**CHAPTER 7: INSTRUMENTATION AND CONTROLS  
TABLE OF CONTENTS**

Turkey Point Units 6 & 7  
COL Application  
Part 2 — FSAR

Figure 7.2-1R Functional Diagram Nuclear Startup Protection (Sheet 1 of 2)

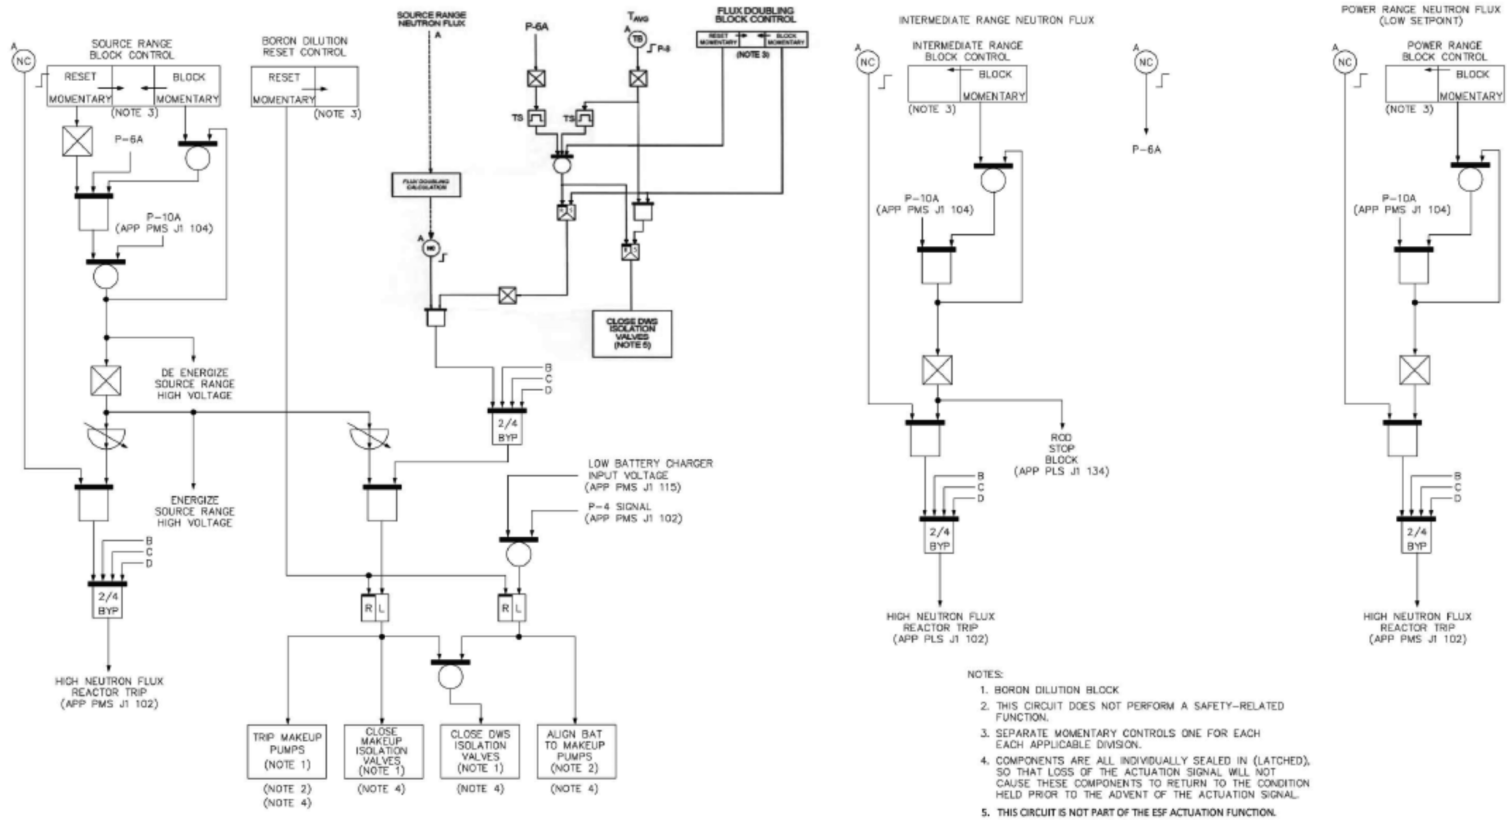
PTN DEP 7.3-1

PTN DEP 7.3-1 Condition 1 is an average of the source range count rate, sampled at least N times over the most recent time period  $T_1$ , compared to a similar average taken at time period  $T_2$  earlier. If the ratio of the current average count rate to the earlier average count rate is greater than a preset value, a partial trip is generated in the division. On a coincidence of excessively increasing source range neutron flux in two of the four divisions, boron dilution is blocked. The Flux Doubling function is also delayed from actuating each time the source range detector's high voltage power is energized to prevent a spurious dilution block due to the short term instability of the processed source range values. This source range flux doubling signal may be manually blocked to permit plant startup and normal power operation when reactor coolant average temperature is above the P-8 setpoint. It is automatically reinstated when reactor power is decreased below the P-6 power level during shutdown or reactor coolant average temperature decreases below the P-8 setpoint.

The Flux Doubling function can also be manually blocked during shutdown conditions when below the P-8 reactor coolant average temperature. When blocked during shutdown conditions, the CVS demineralized water system isolation valves are automatically closed to prevent inadvertent boron dilution.

Figure 7.2-1R Functional Diagram Containment and Other Protection (Sheet 2 of 2)

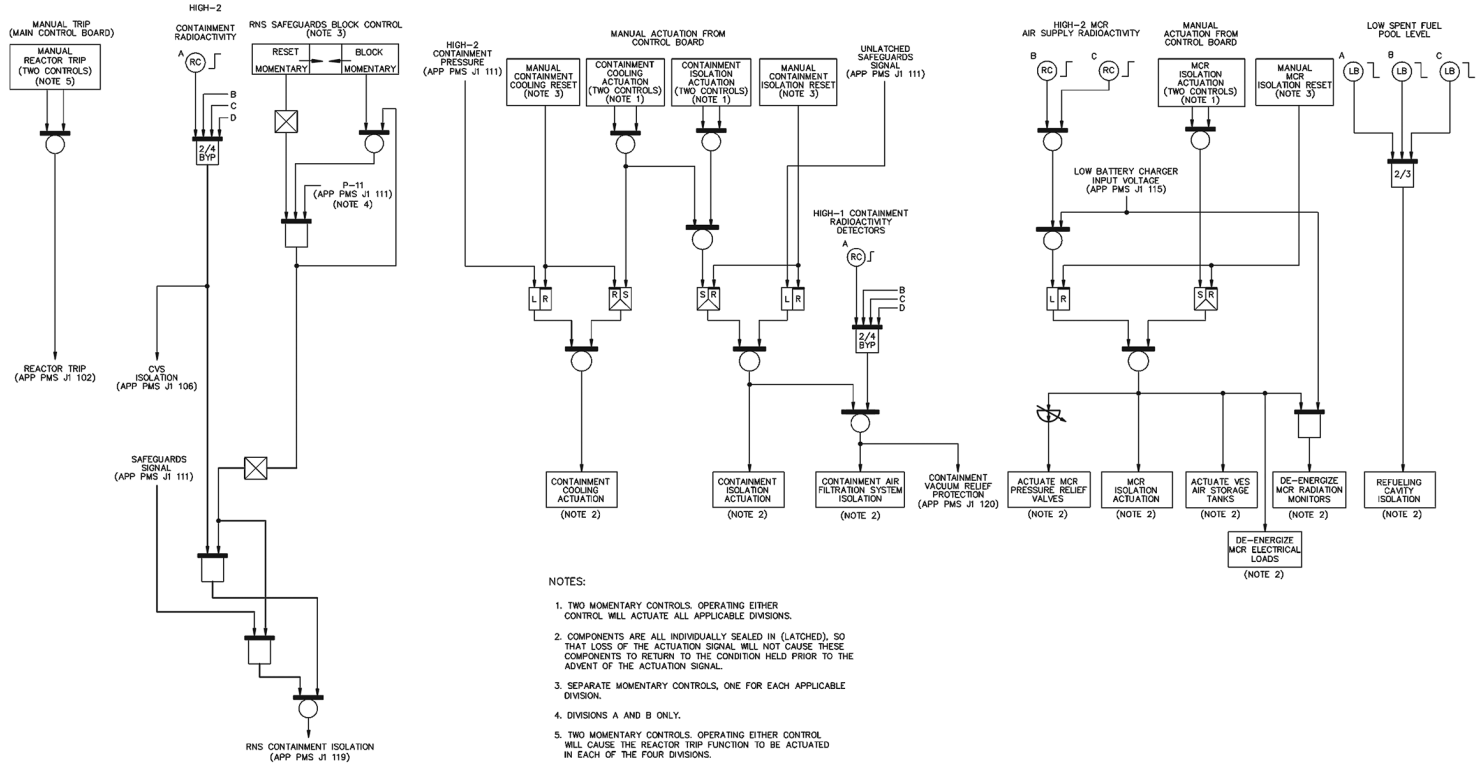
PTN DEP 6.4-2

PTN DEP 6.4-2 Signals to initiate isolation of the main control room, to initiate the air supply, and to open the main control room pressure relief isolation valves and to de-energize non-essential main control room electrical loads are generated from any of the following conditions:

1. High-2 control room air supply radioactivity level
2. Loss of ac power sources (low Class 1E battery charger input voltage)
3. Manual initiation

PTN DEP 6.4-1 Condition 1 is the occurrence of one of two main control room air supply  
PTN DEP 6.4-2 radioactivity monitors detecting the iodine or particulate radioactivity level above the High-2 setpoint.

PTN DEP 6.4-2 Condition 2 results from the loss of all ac power sources. A preset time delay is provided to permit the restoration of ac power from the offsite sources or from the onsite diesel generators before initiation. The loss of all ac power is detected by undervoltage sensors that are connected to the input of each of the four Class 1E battery chargers. Two sensors are connected to each of the four battery charger inputs. The loss of ac power signal is based on the detection of an undervoltage condition by each of the two sensors connected to two of the four battery chargers. The two-out-of-four logic is based on an undervoltage to the battery chargers for divisions A or C coincident with an undervoltage to the battery chargers for divisions B or D.

PTN DEP 6.4-2 Condition 3 consists of two momentary controls. Manual actuation of either of the two controls will result in main control room isolation, air supply initiation, and electrical load de-energization.

PTN DEP 6.4-2 The functional logic relating to main control room isolation, air supply initiation, and electrical load de-energization is illustrated in [Figure 7.2-1R](#) (Sheet 2 of 2).
